Addendum #4

East Lake Community Center Renovations

CONTRACT NO. Y-17-005

4 GYM 102 LOOKING NORTH
SCALE: 1/8" = 1'-0"

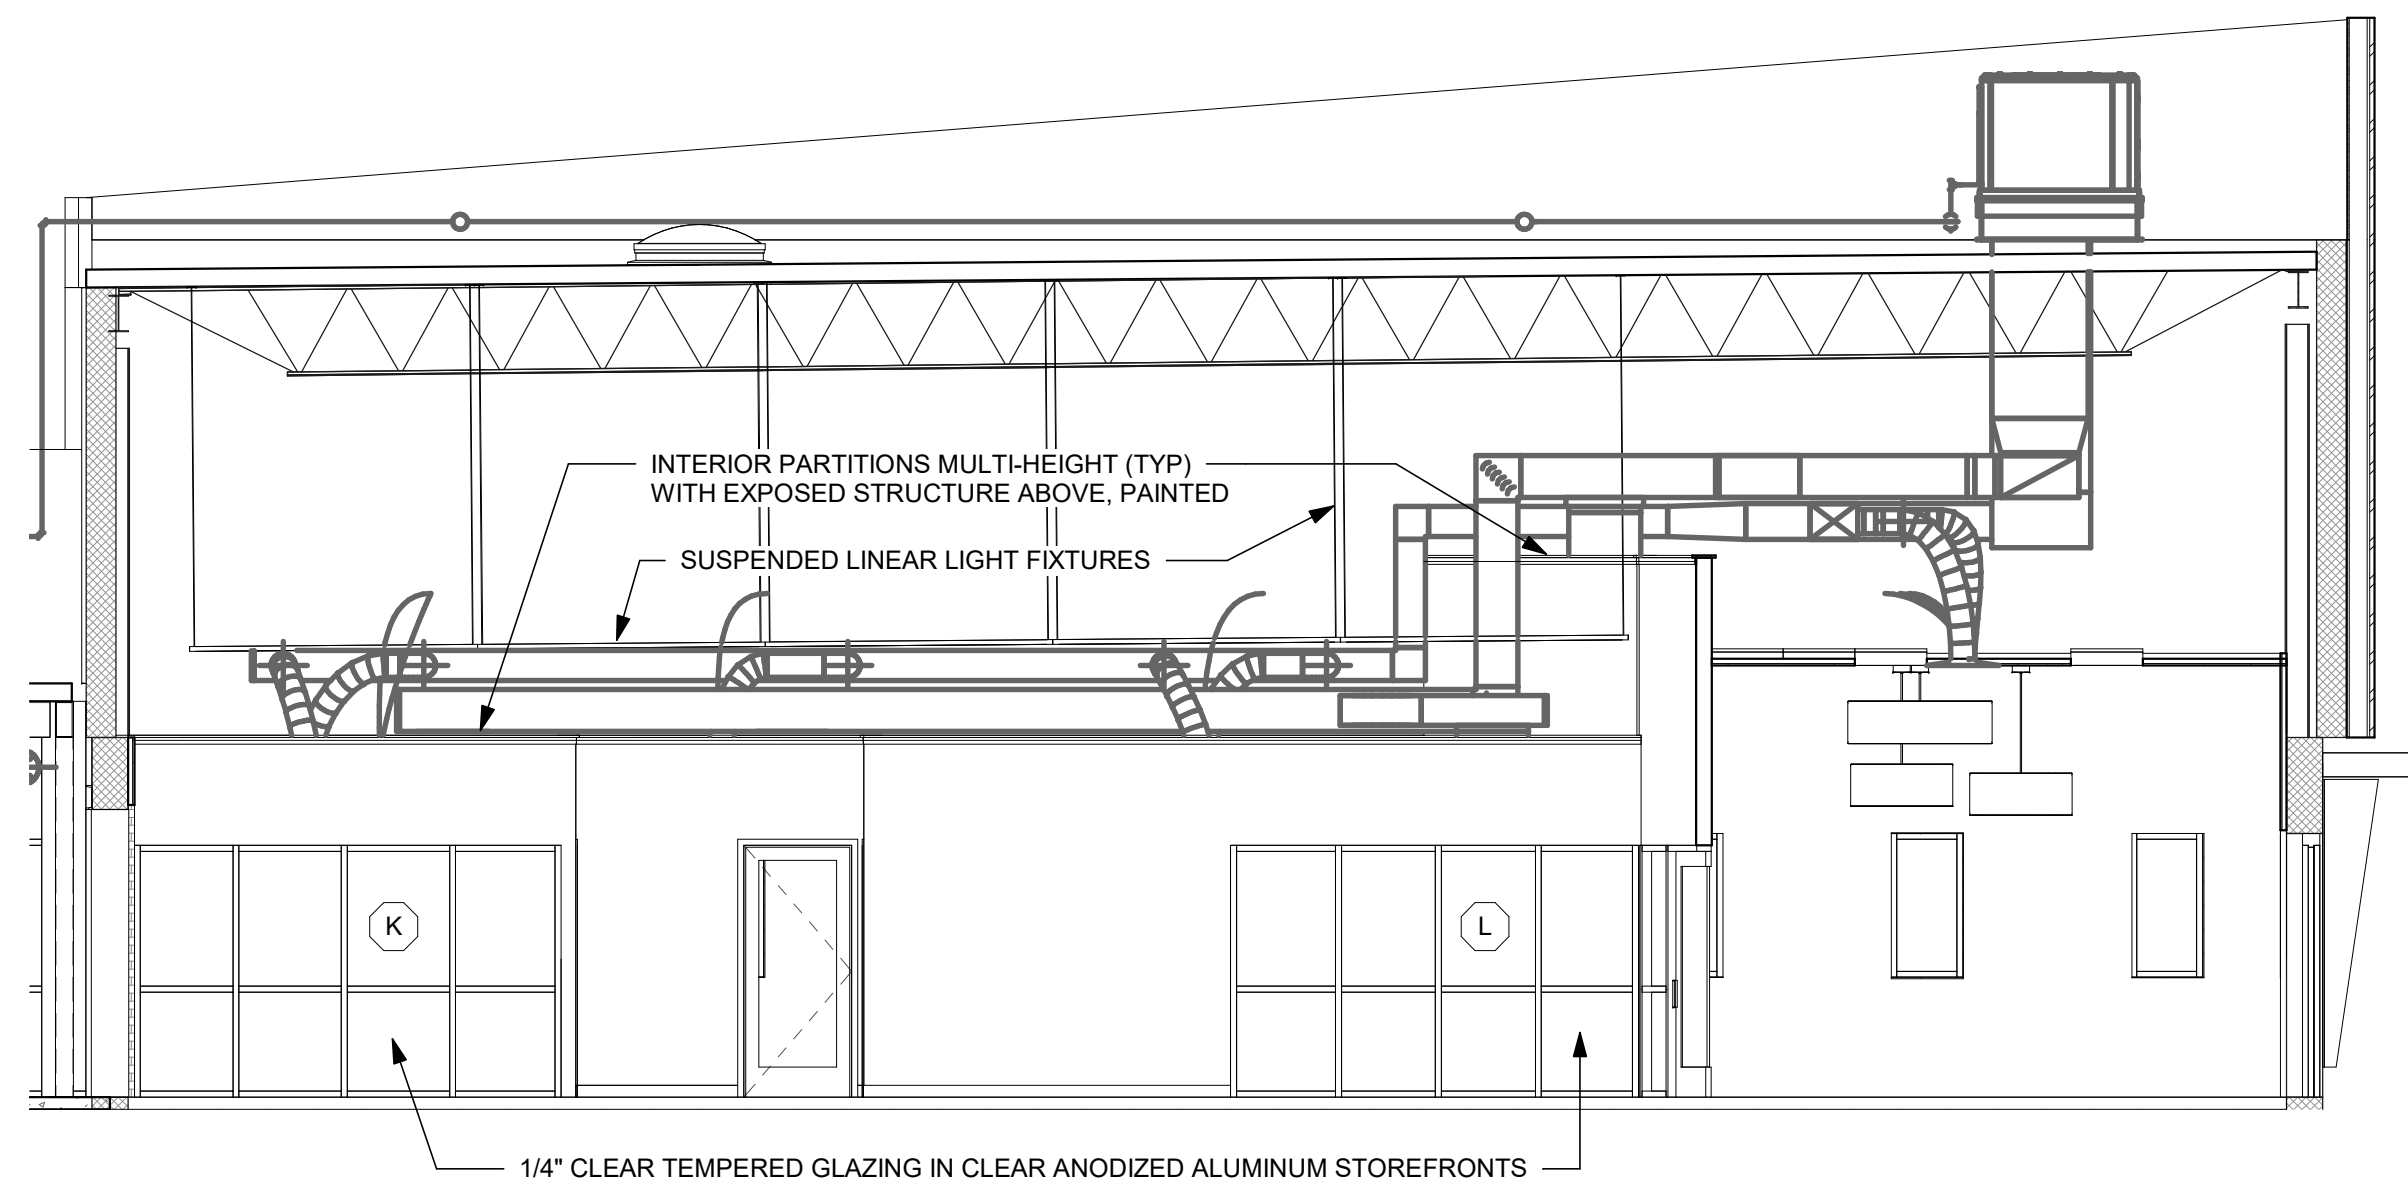
- Gym 102 Looking West 1: modified to indicate finishes and acoustical wall panels.
- Gym 102 Looking North 4: modified to note locations for protective pads.
- Corridor Elevations 5 & 6: Modified to note storefront window types.

1 MULTI-PURPOSE ROOMS LOOKING NORTH
 SCALE: 3/16" = 1'-0"

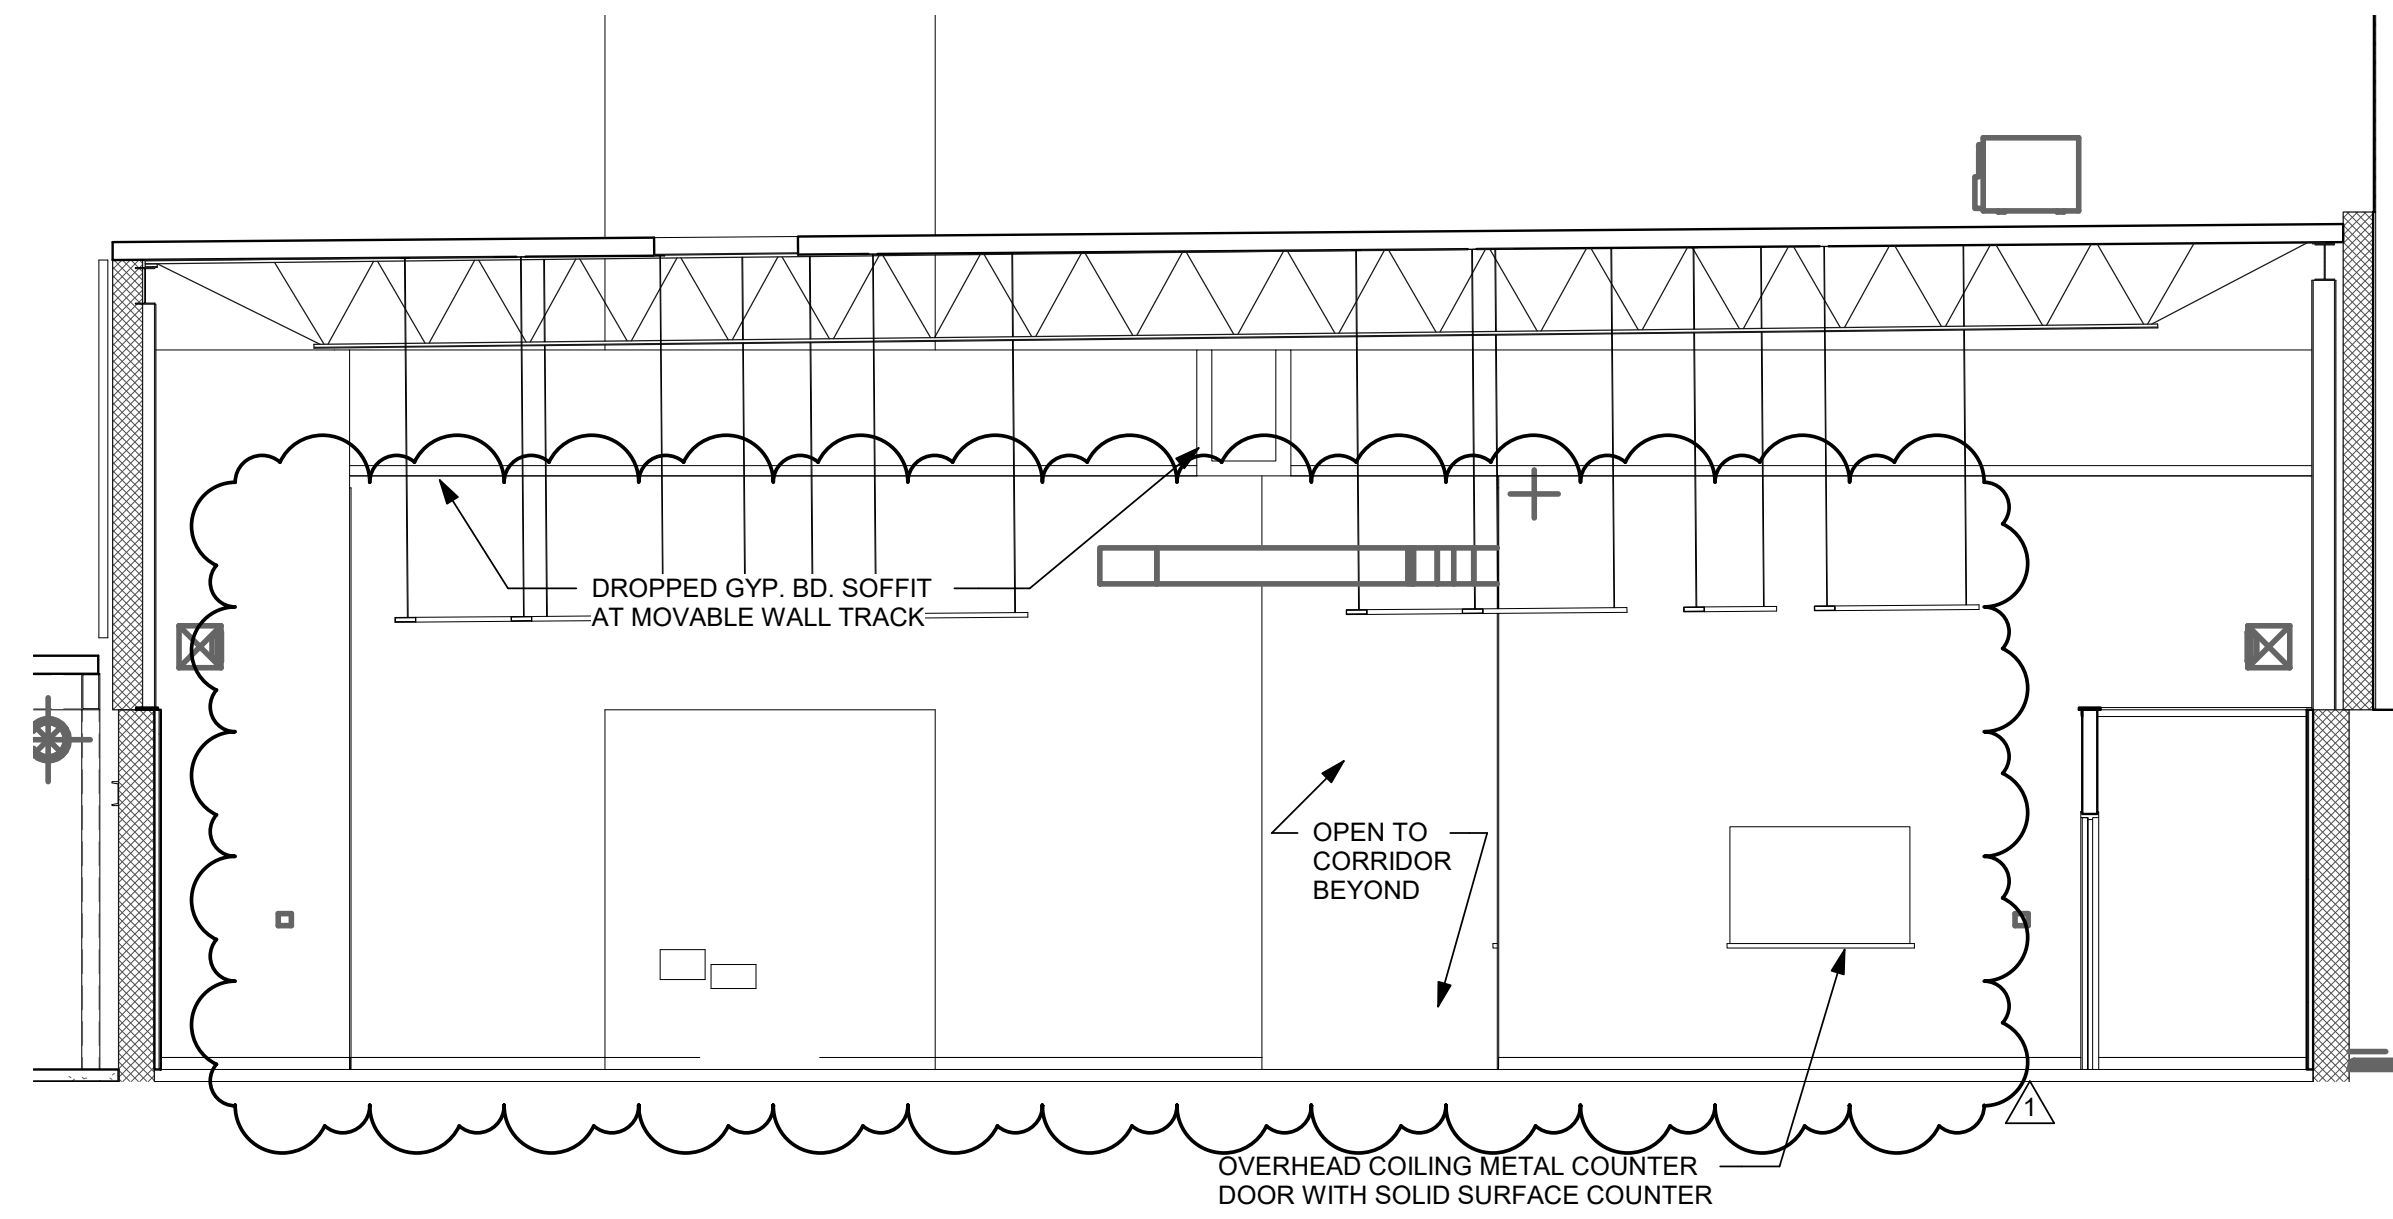
- Multi-Purpose Rooms Looking North 1: clarified tall doors for movable partition storage closet.
- Multi-Purpose Rooms looking South 2: Noted overhead coiling door.
- Multi-purpose Rooms Looking West 3: added clarification notes.
- Multi-Purpose Rooms Looking East 4: indicated portable partition.

5 PARTITION SUPPORT DETAIL
SCALE: 3/4" = 1'-0"

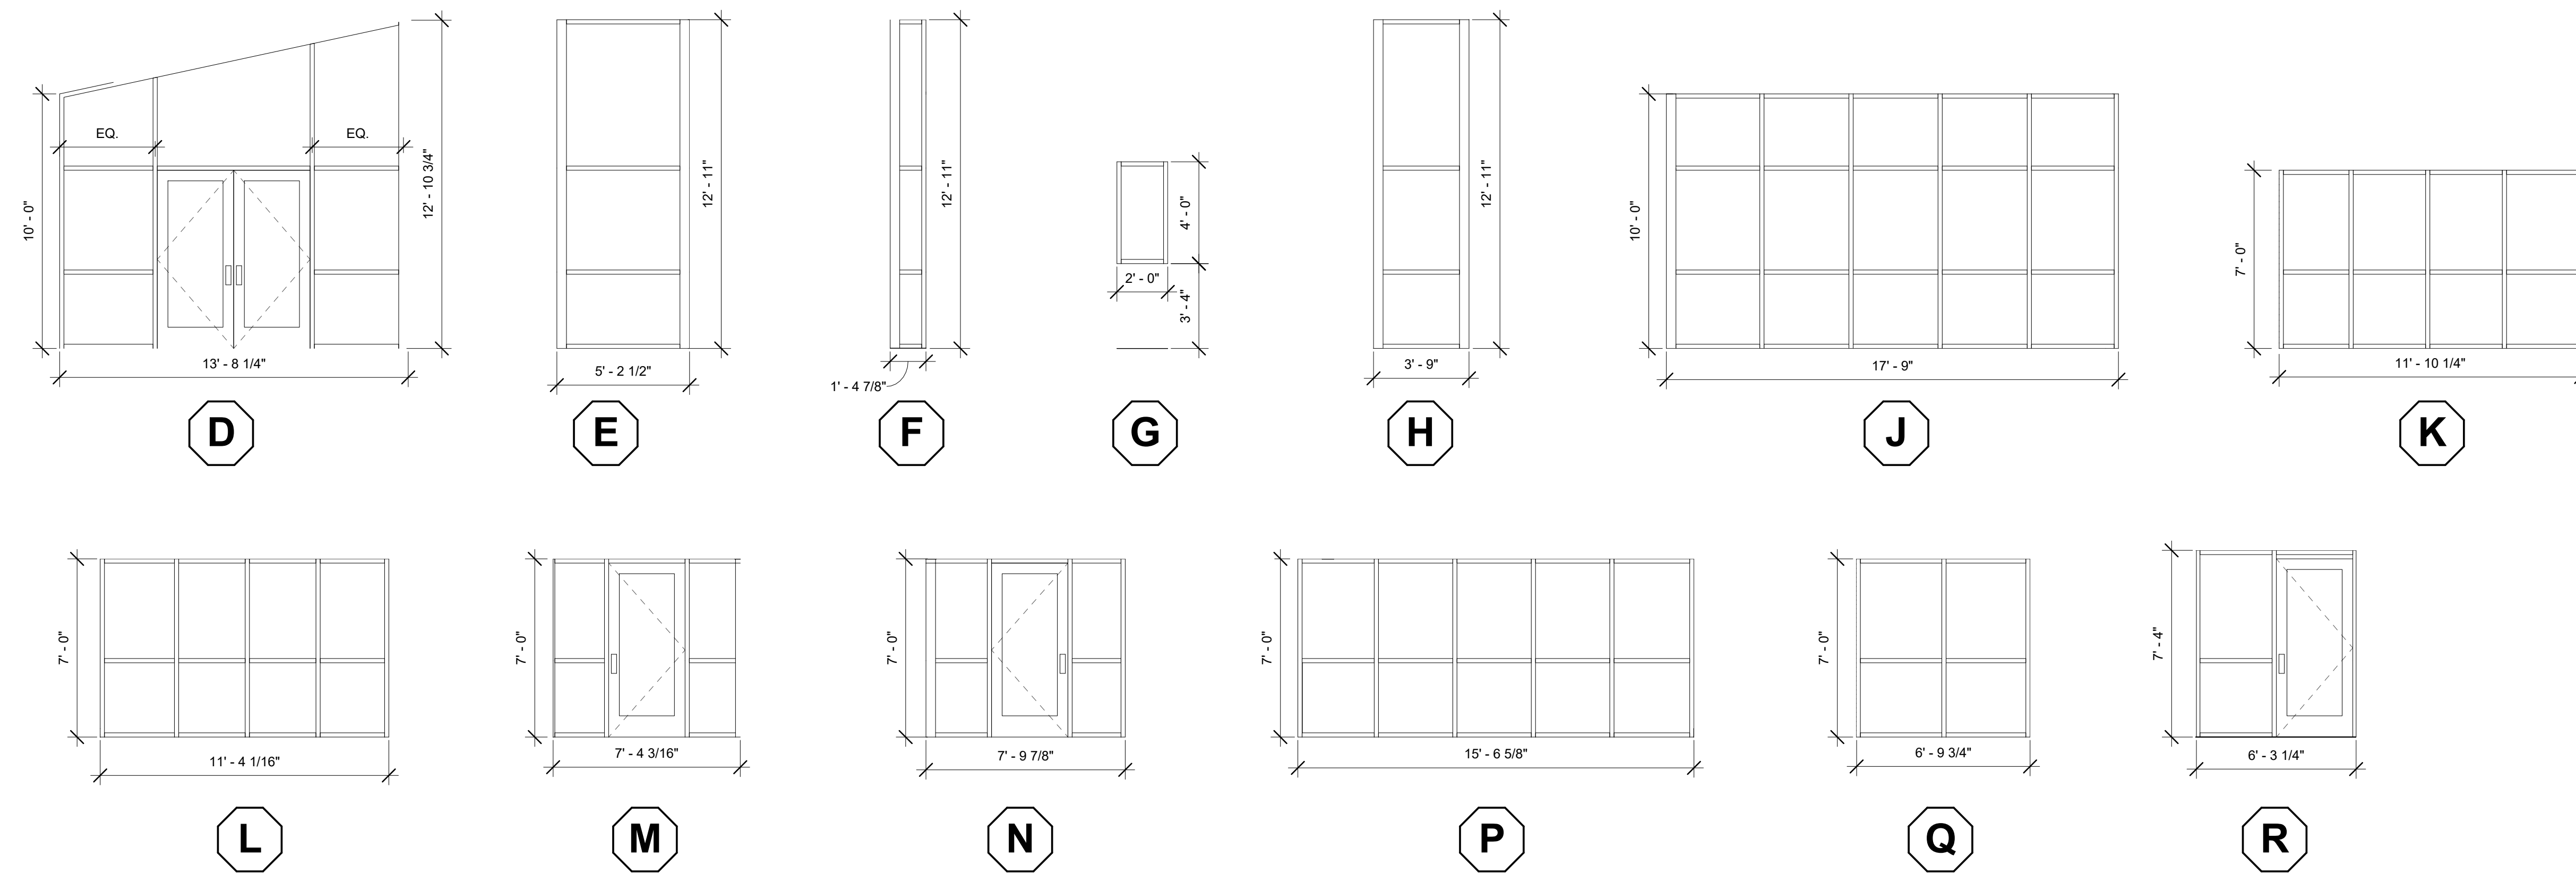
- Sections 4 & 5: Updated.
- Partition Support Detail: added as part of this addendum.
